U.S. Department of Energy  
**Office of River Protection**

11-ESQ-241

U.S. DEPARTMENT OF ENERGY (DOE), OFFICE OF RIVER PROTECTION (ORP)  
SUBMITTAL OF CLOSURE REPORTS FOR SIX EMISSION UNITS IN THE HANFORD  
SITE AIR OPERATING PERMIT (AOP), PERMIT NUMBER 00-05-006/LICENSE NUMBER  
FF-01

Report of Closure for Emission Units

H-2-90906, Sheet 1, Rev. 8 HVAC Equipment Plans Elevation and Details

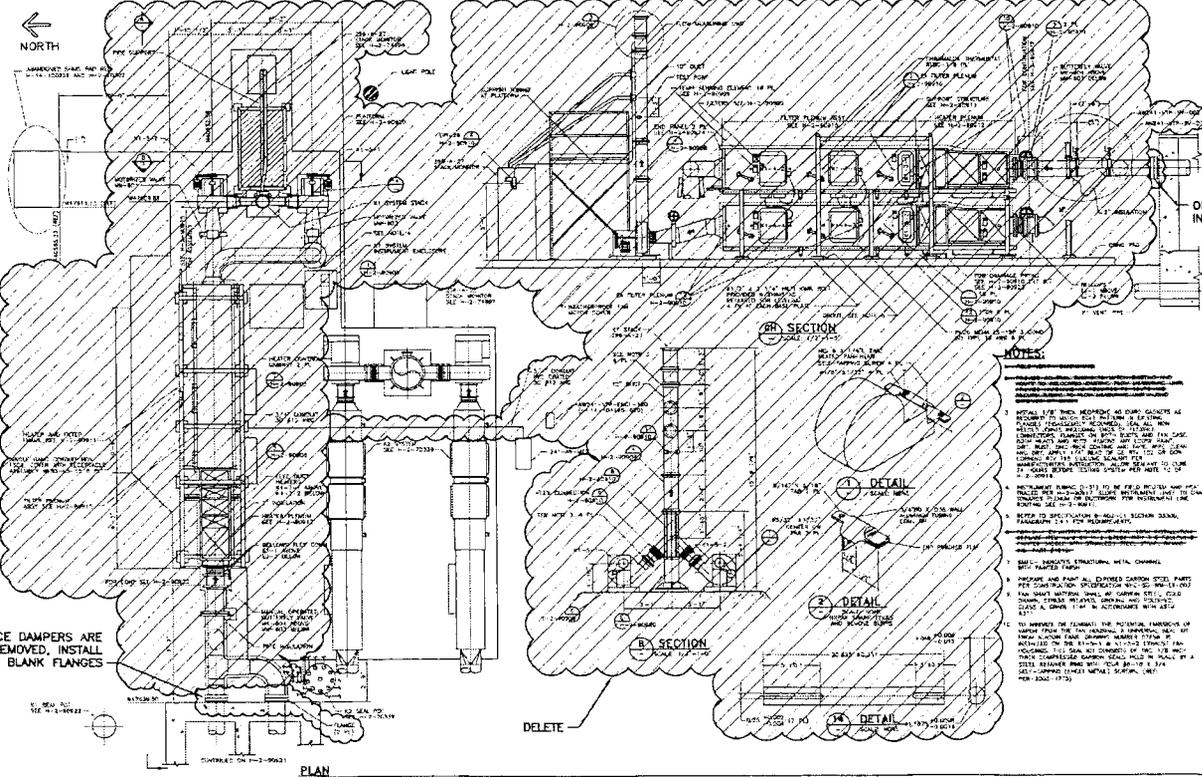
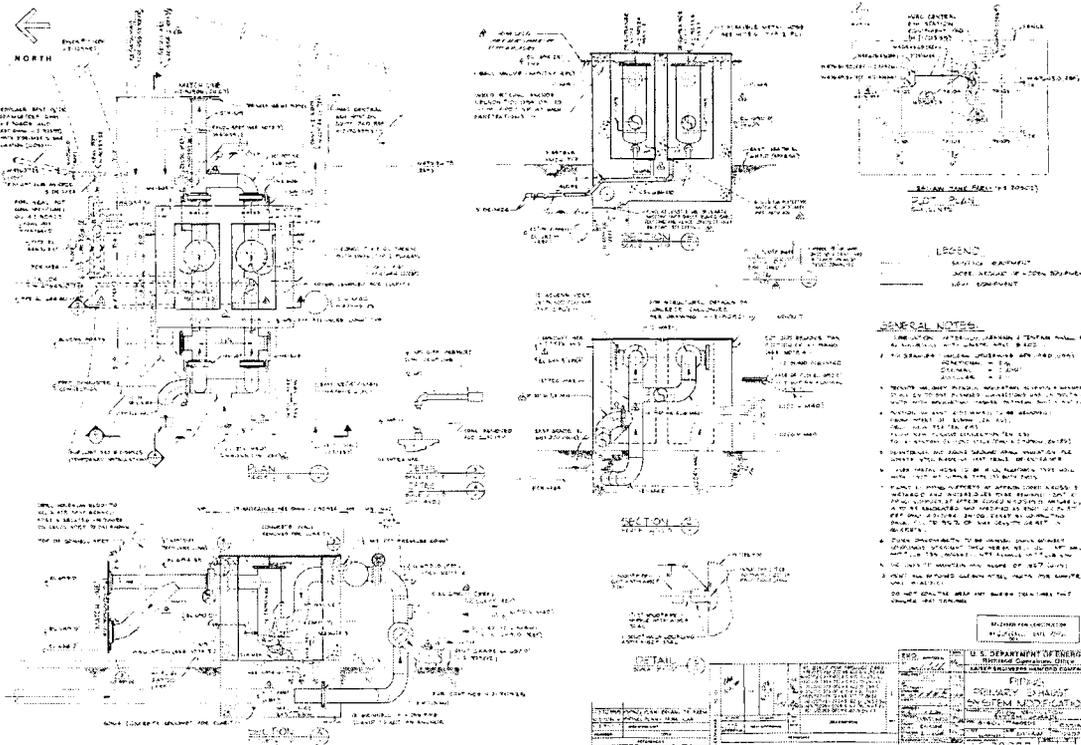
Revise drawing to show isolation and removal of the K1 system above grade. Seal pot, concrete pad and associated dimensioning are to remain. See pages 5 & 6 of this ECN.

IS: ECN NOTE: (DO NOT INCORPORATE)  
SEAL POT, CONCRETE PAD AND ASSOCIATED  
DIMENSIONING TO REMAIN.

H-14-020102, Sheet 2, Rev. 14 AW VTP P&ID

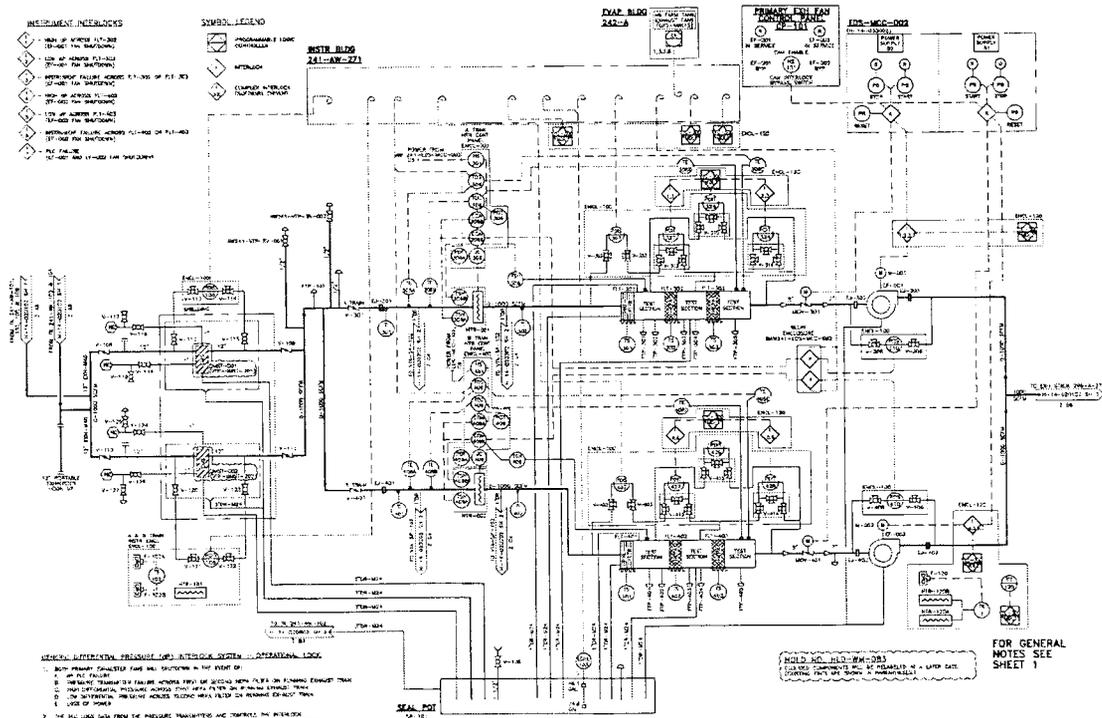
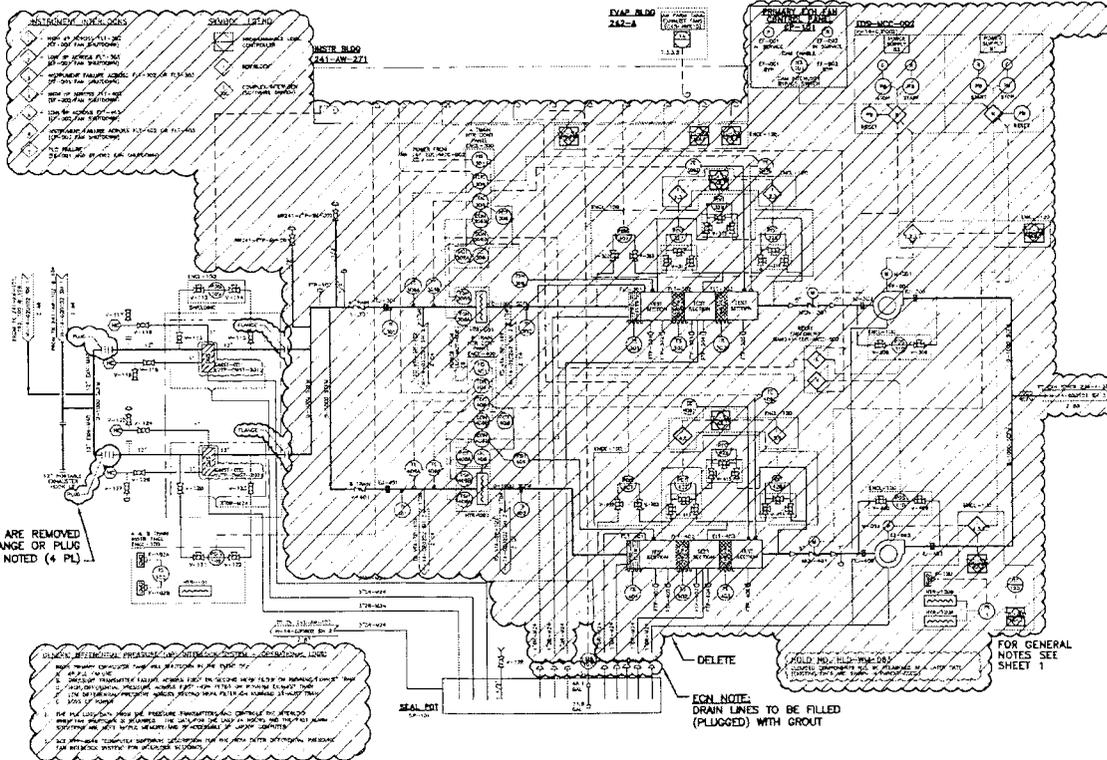
Revise drawing to show isolation and removal of the K1 system. Associated piping to be cut and capped at grade. See pages 9 & 10 of this ECN.

REMOVE REFERENCED PIPING AND SYSTEM COMPONENTS, LOGS

H-14-020102, Sheet 3, Rev. 7 AW VTP Stack Monitor P&ID

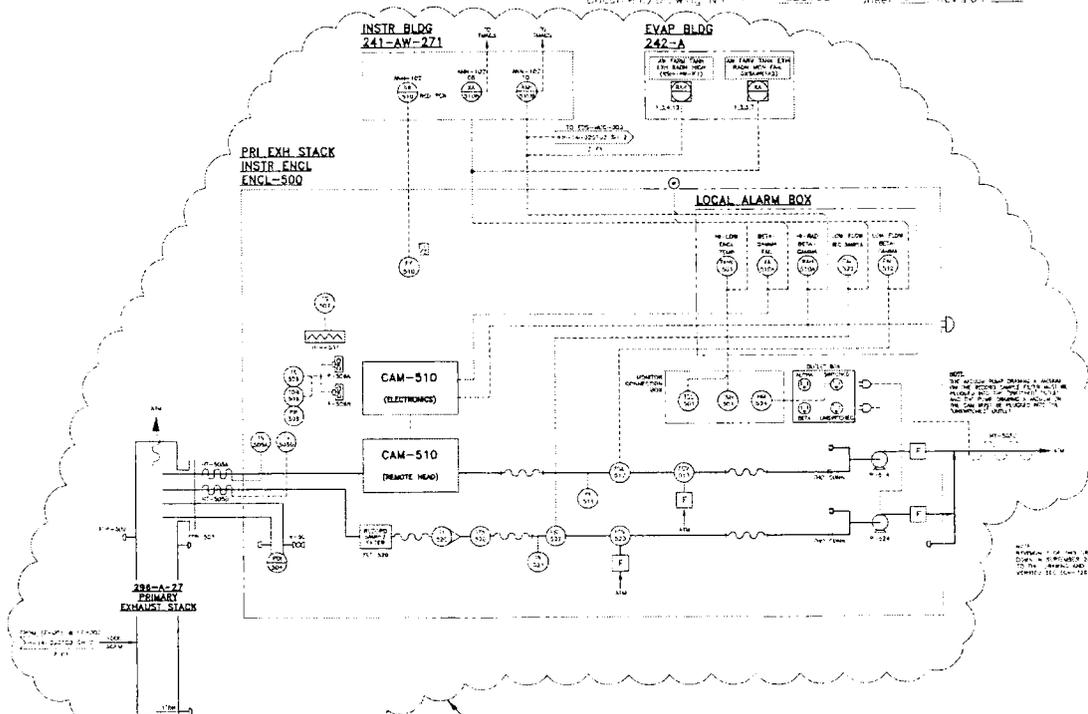
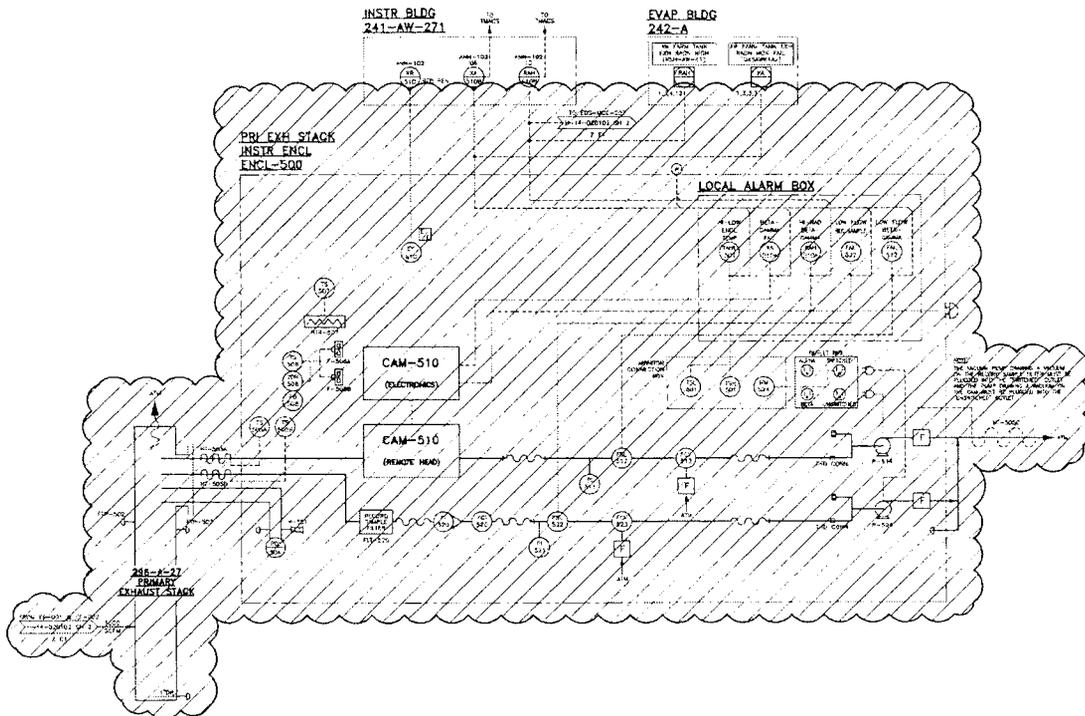
Revise drawing to show isolation and removal of the K1 system. See pages 11 & 12 of this ECN.

Document/Drawing No. H-14-030013 Sheet 2 Revision 9

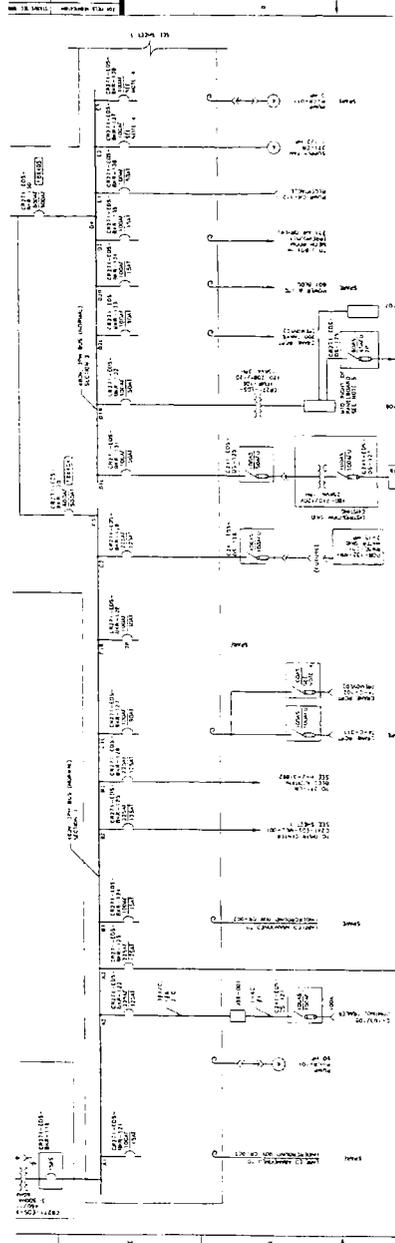
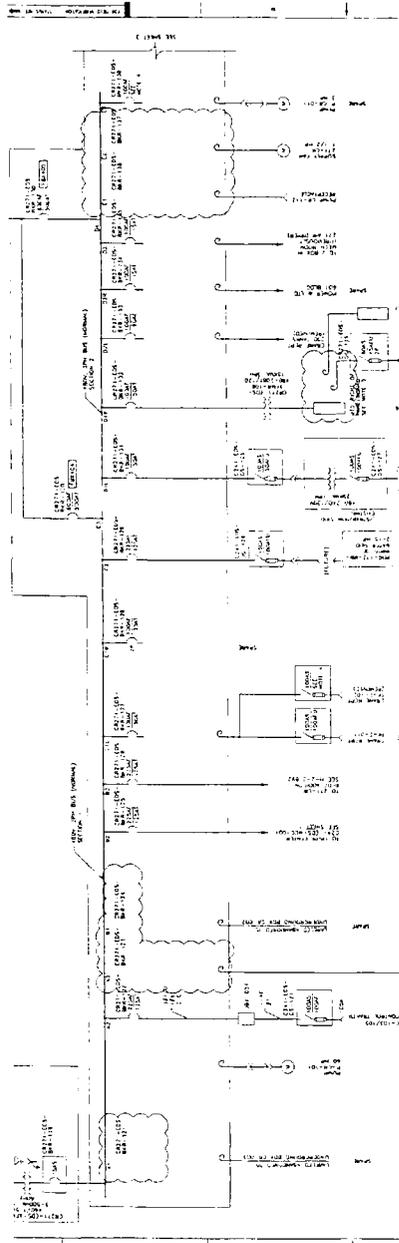
THIS PAGE REPLACES PAGE 5 OF ECN-724070-R0  
AND CORRESPONDING PORTION OF PAGE 7 OF  
ECN-723552-R0

IS: REMOVE BREAKERS AND DISCONNECT EQUIPMENT SHOWN

Document/Drawing No. H-14-03001.3 Sheet 3 Revision 5

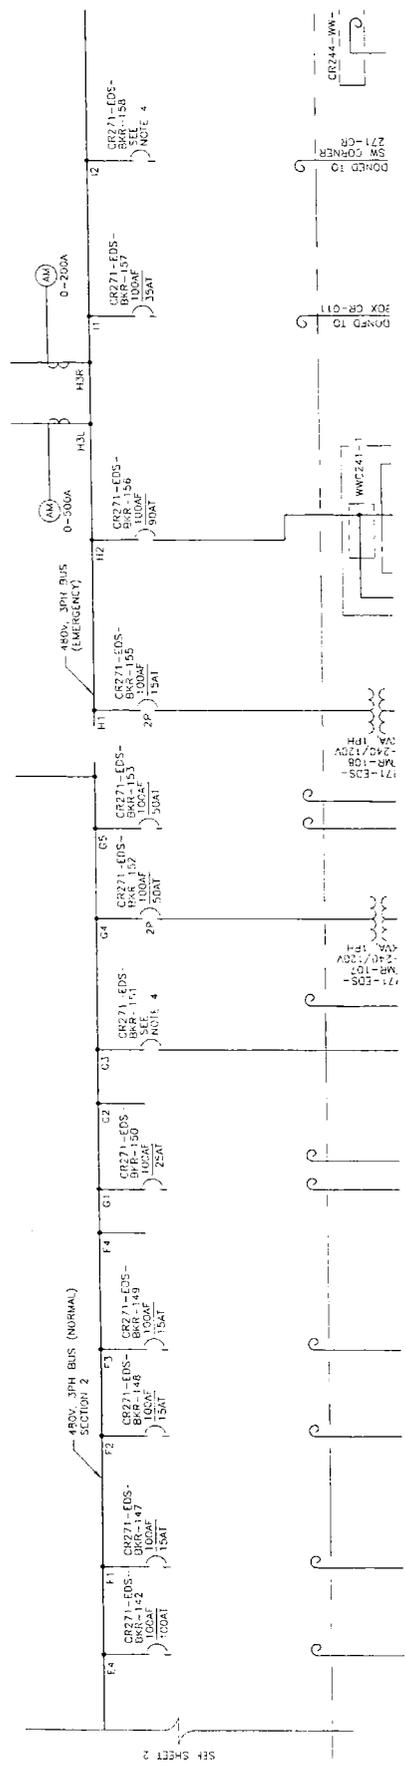
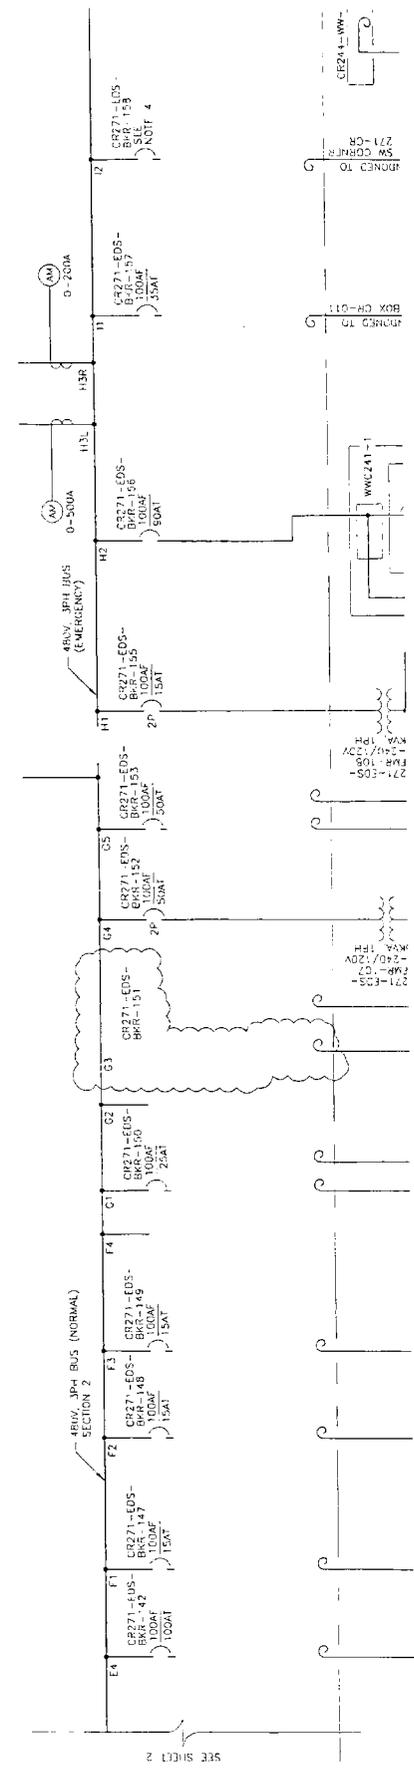
IS: DISCONNECT EQUIPMENT AND REMOVE BREAKER AS INDICATED

Document/Drawing No. H-14-030013 Sheet 3 Revision B

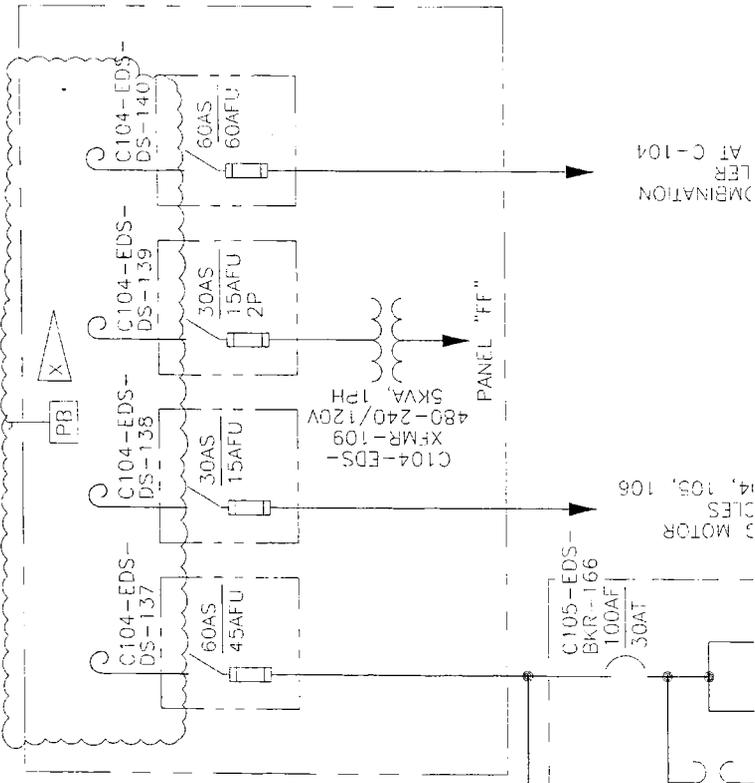
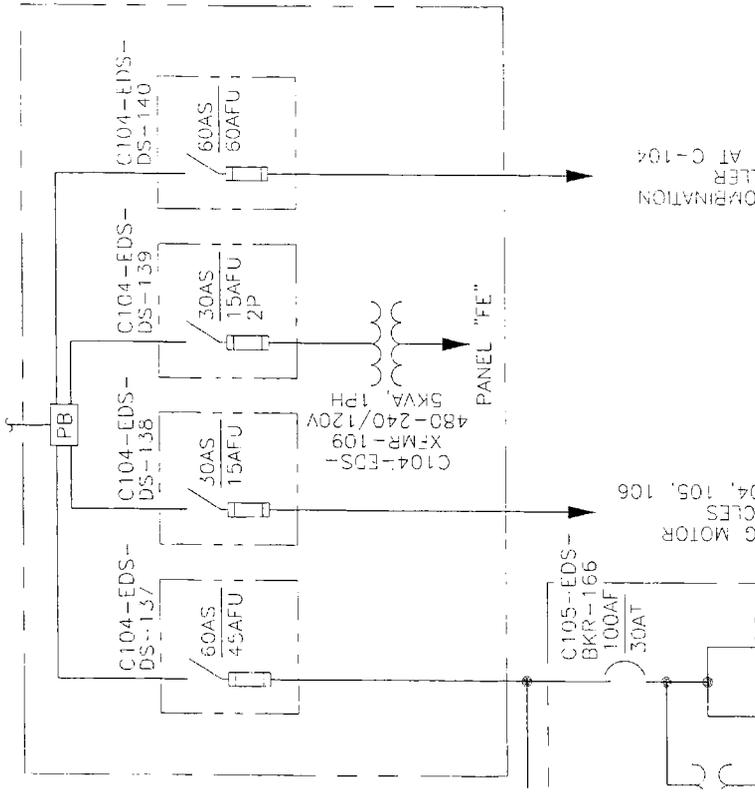
ECN NOTE: DELETE OR REVISE CLOUDED AREAS ONLY
